S/M Fix: A/T Removal, '99-02 Odyssey

**HONDA ServiceNews**

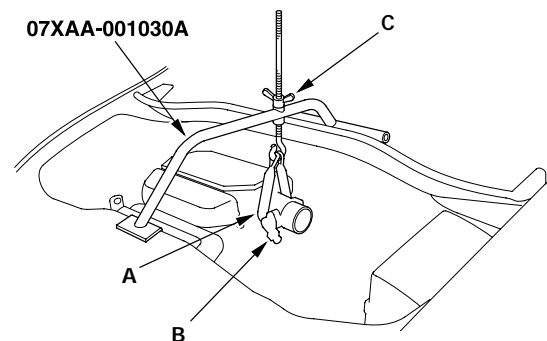
Step 28 on page 14-376 of the 1999-02 Odyssey Service Manual tells you to use an engine hanger (T/N 07XAA-001030A) to lift and support the engine during transmission removal. This hanger *doesn't* work on an '02 model. The '02 model has a higher intake manifold that requires a shorter cable eye/bolt assembly for the engine support hanger. Honda Special Tools recently shipped all dealers a cable eye/bolt assembly (T/N 07ZAA-S0XA100) for this purpose.

Mark up your copies of the S/M to look like this:

28. Lift and support the engine with ~~an engine hanger (T/N 07XAA-001030A, available through the American Honda Tool and Equipment Program).~~ Position the tool over the hood latch. Loop the cable (A) around the throttle body (B), and tighten the wing nut (C) on the tool by hand until the cable is tight.

NOTE: For '02 model, replace the cable eye/bolt assembly (A) on the engine support hanger with T/N 07ZAA-S0XA100.
